ADDENDUM NUMBER THREE
TO THE CONTRACT DOCUMENTS FOR CONSTRUCTION OF
ORANGE BEACH RECREATION COMPLEX
NEW BASEBALL/SOFTBALL FIELD RENOVATIONS AT ORANGE BEACH SPORTSPLEX
CITY OF ORANGE BEACH

This addendum forms a part of the Contract Documents and modifies the Bid Documents dated May 4, 2020.

This Addendum consists of three (3) page Addendum, one (1) general documents, one (1) Specification & thirteen (13) full-size sheets.

DRAWING NO.
LS102

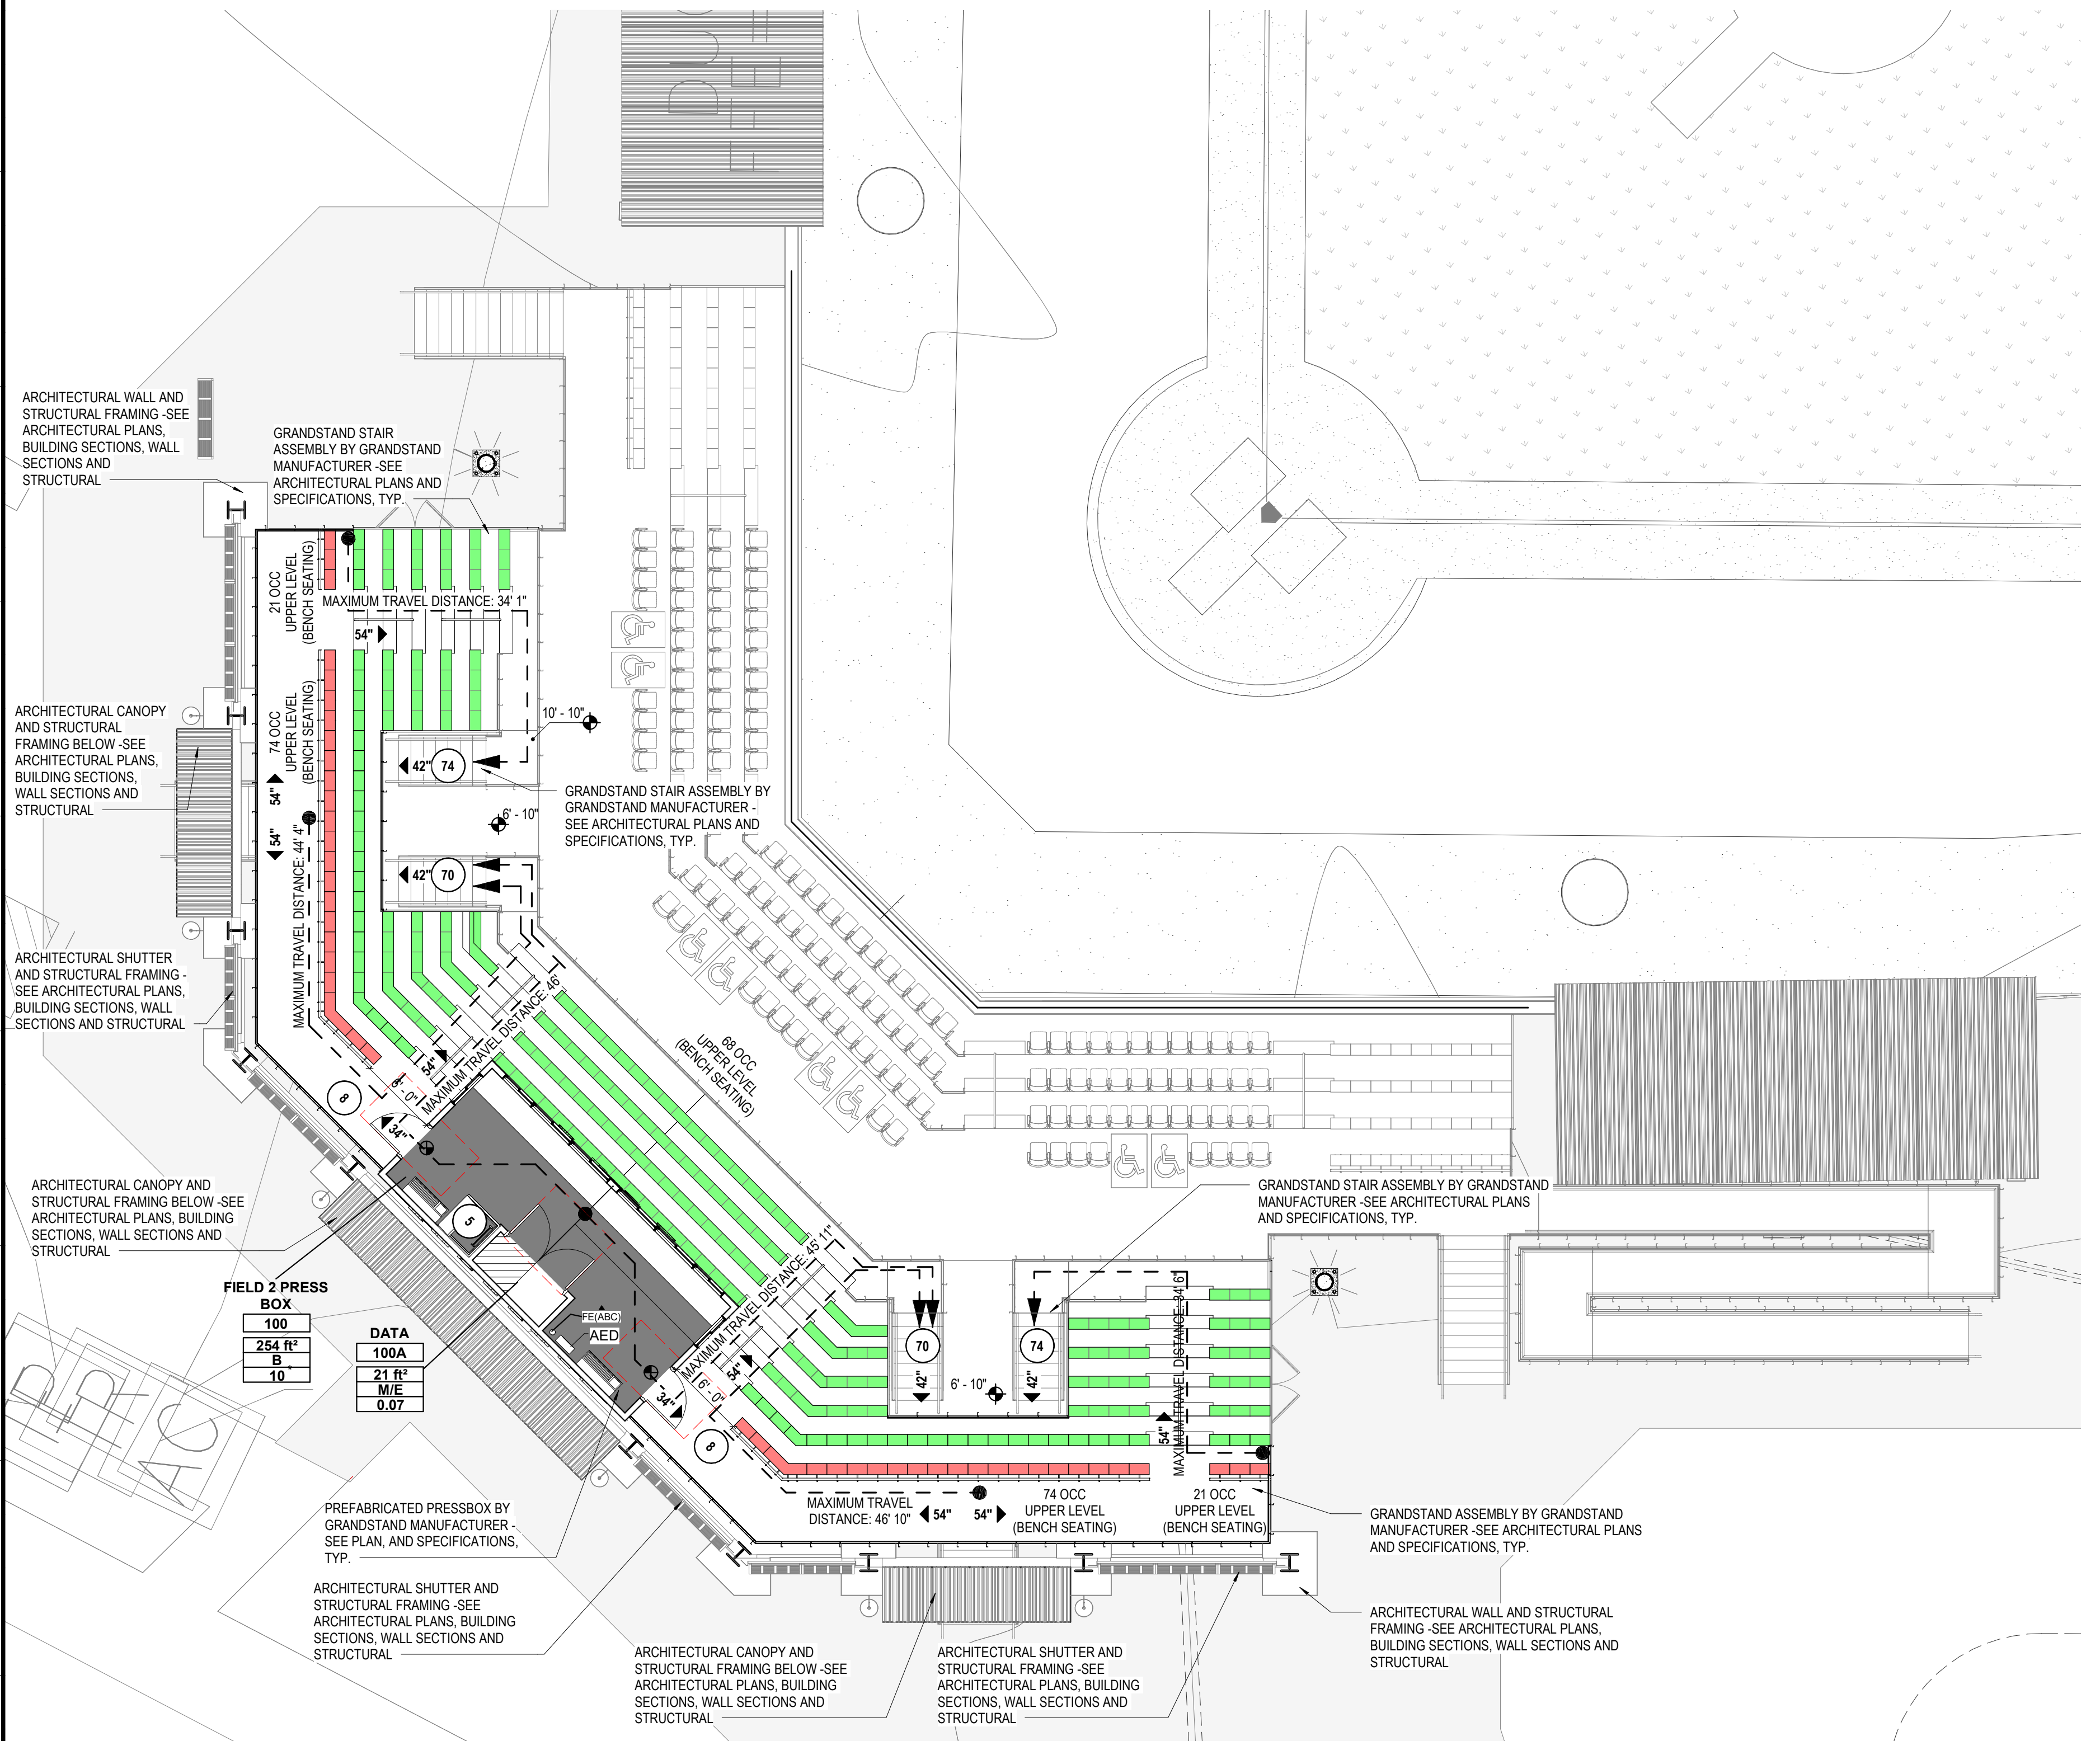
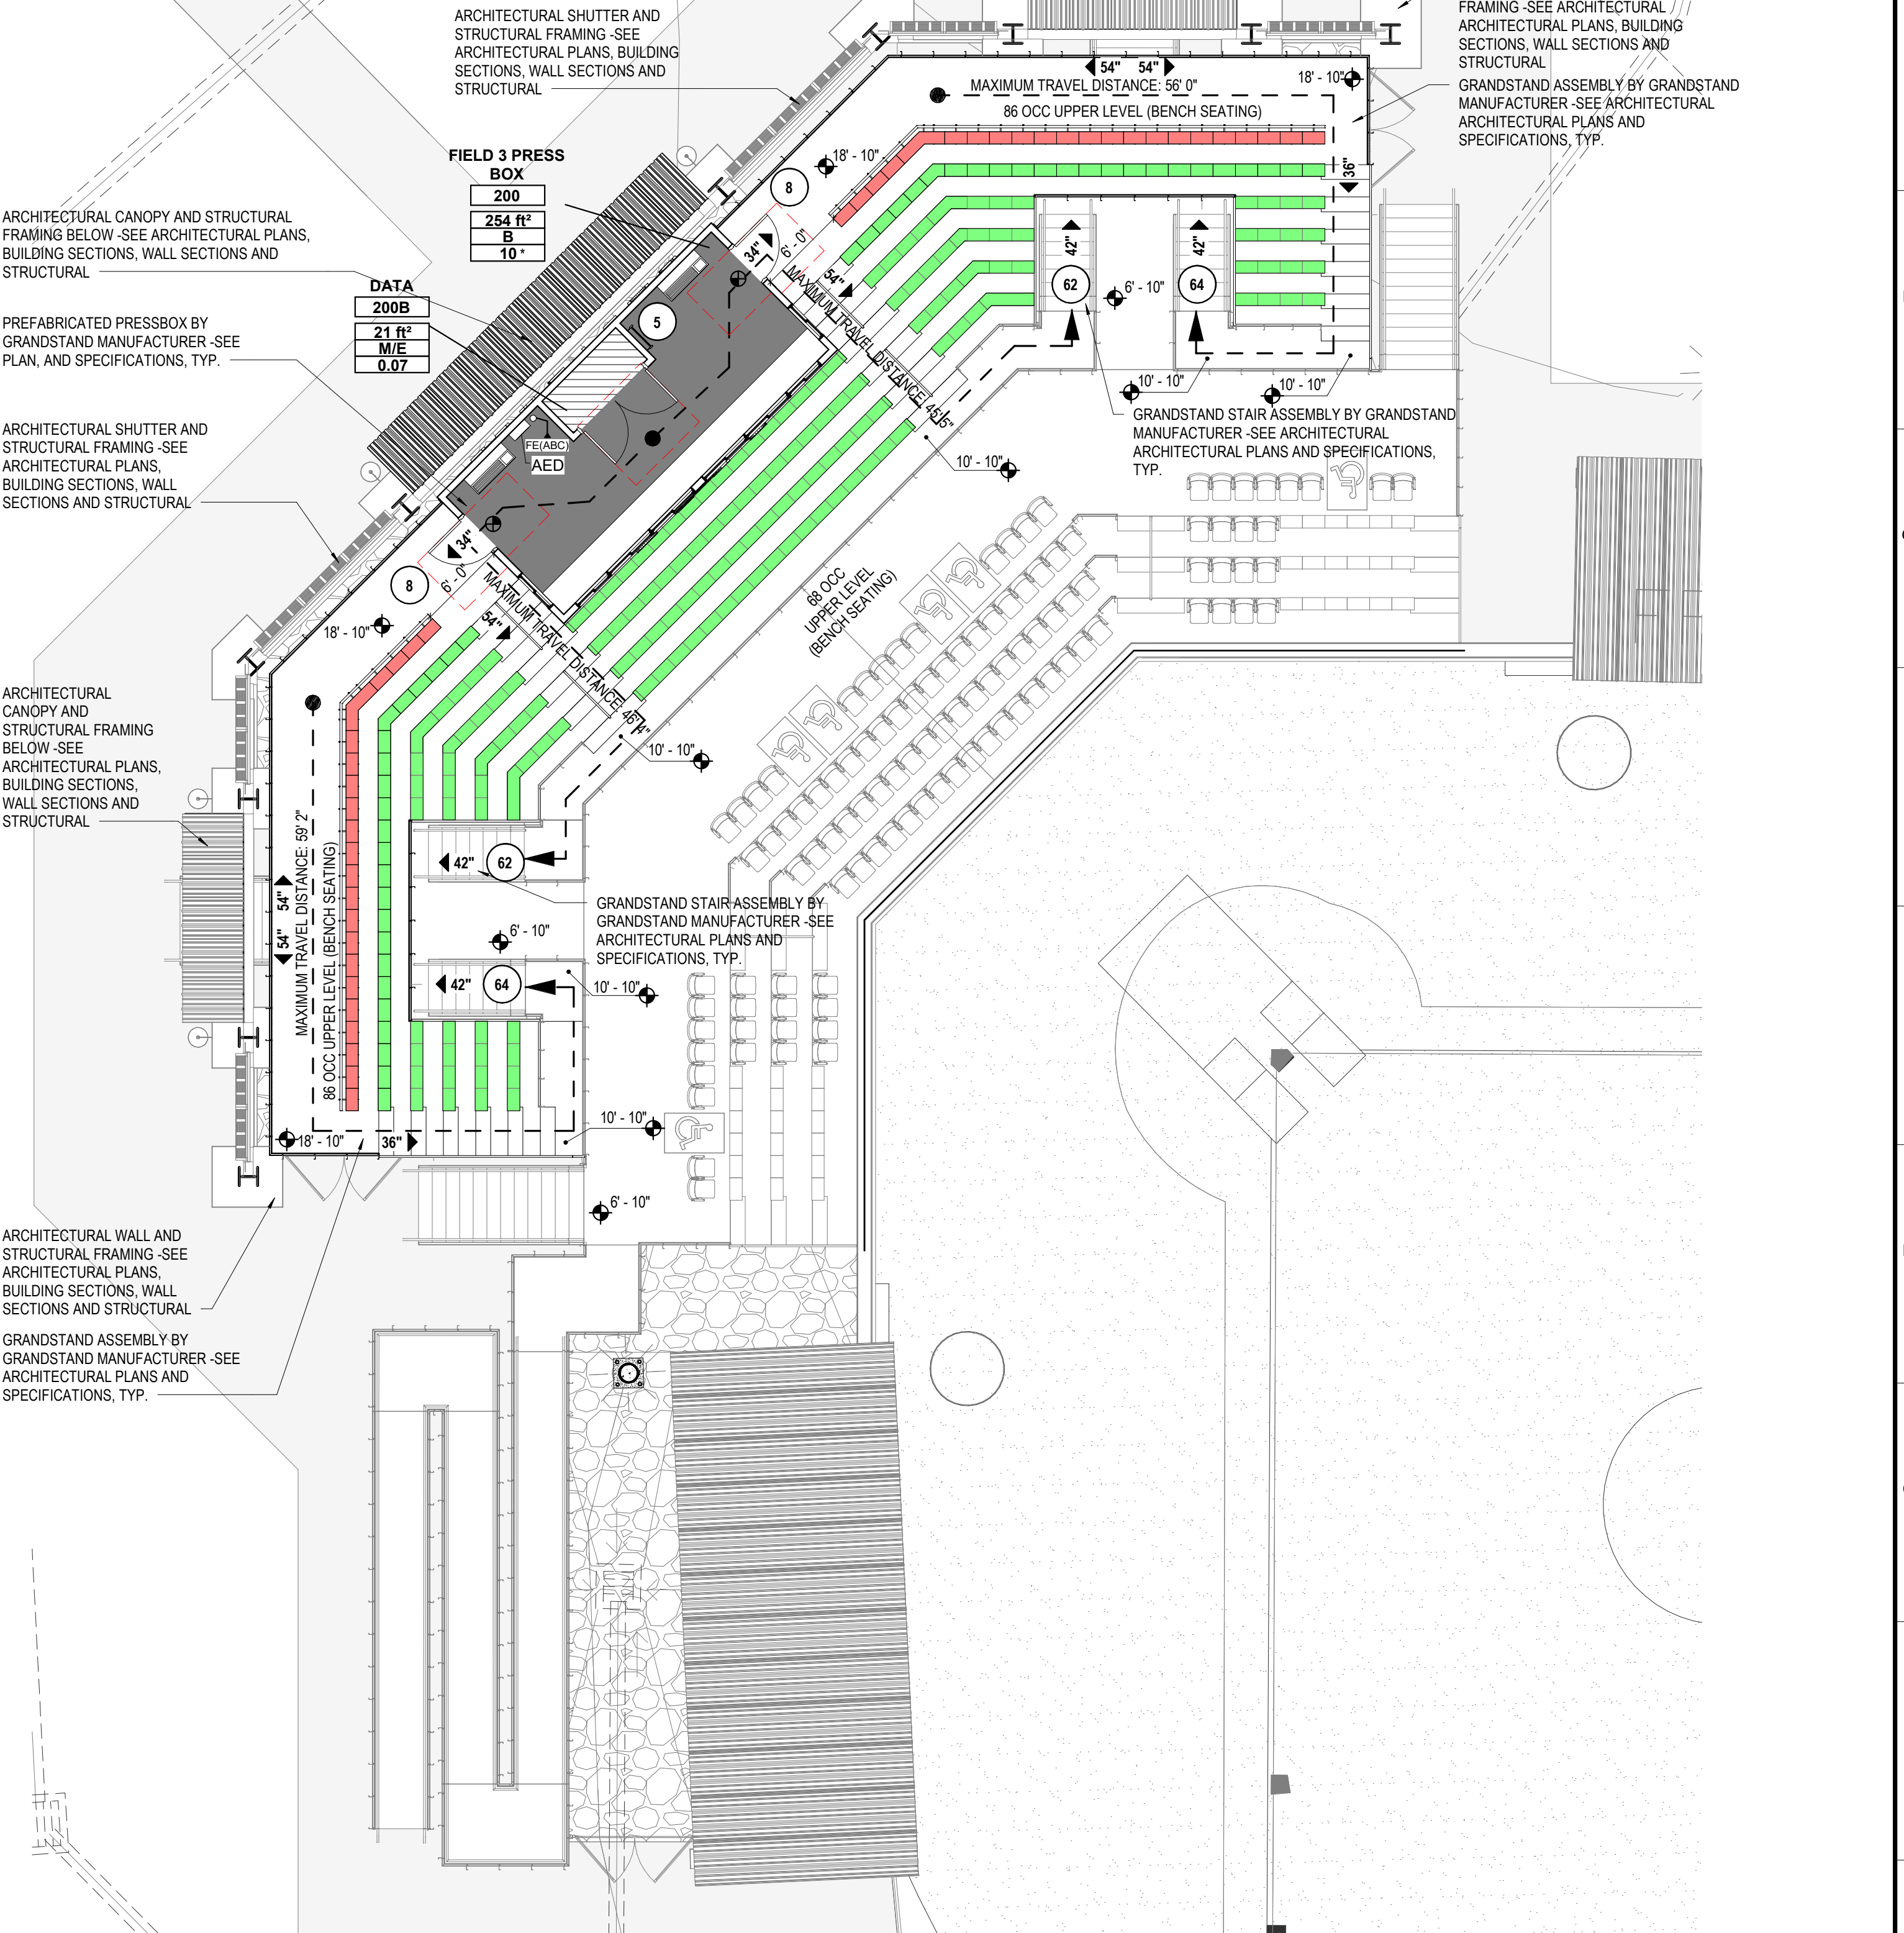
ITEM 07 SHEET LS102 – PRESS BOX LEVEL AND UPPER SEATING GRANDSTAND – LIFE SAFETY PLANS

1. Revised Symbols Legend:
 - a. Remove Type C from Legend
 - b. Add Fire Extinguisher Cabinet symbol
2. Add note to General Notes for additional number of Fire Extinguisher Cabinets to be provided.

DRAWING NO.
A002

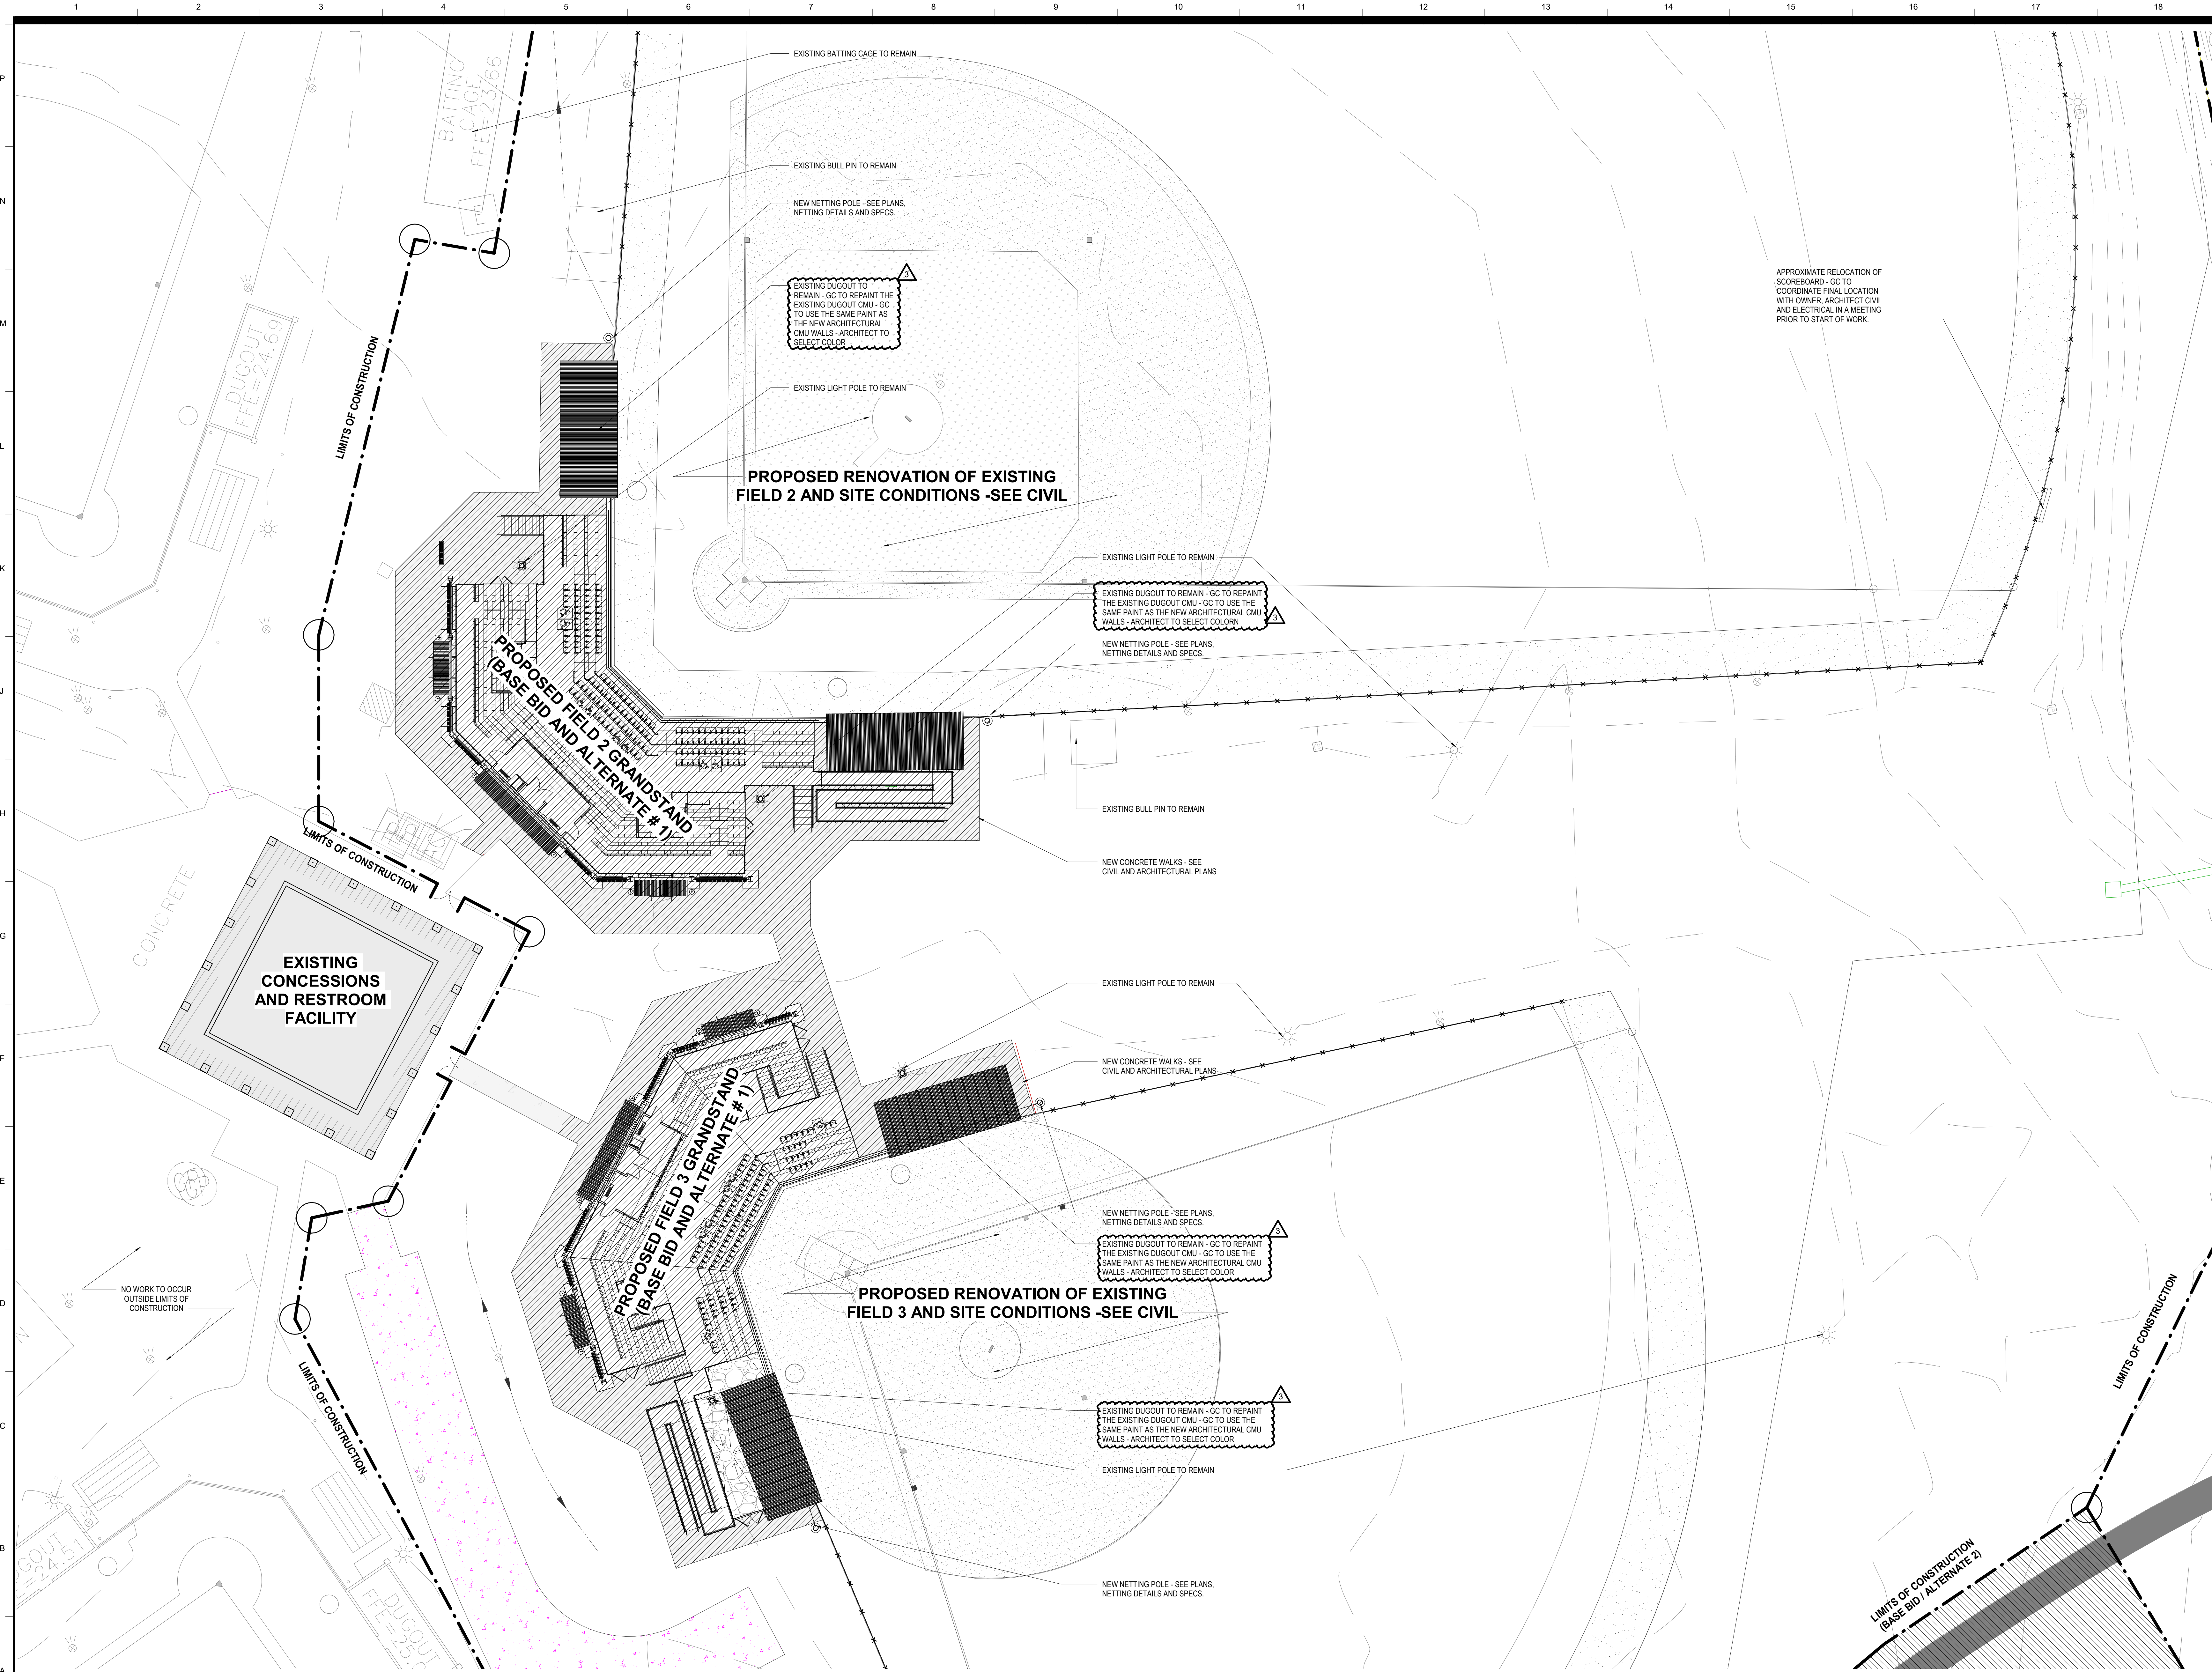
ITEM 08 SHEET A002 – ARCHITECTURAL SITE PLAN

1. Revised Notes for existing dugout – existing dugout cmu to be repainted by GC.
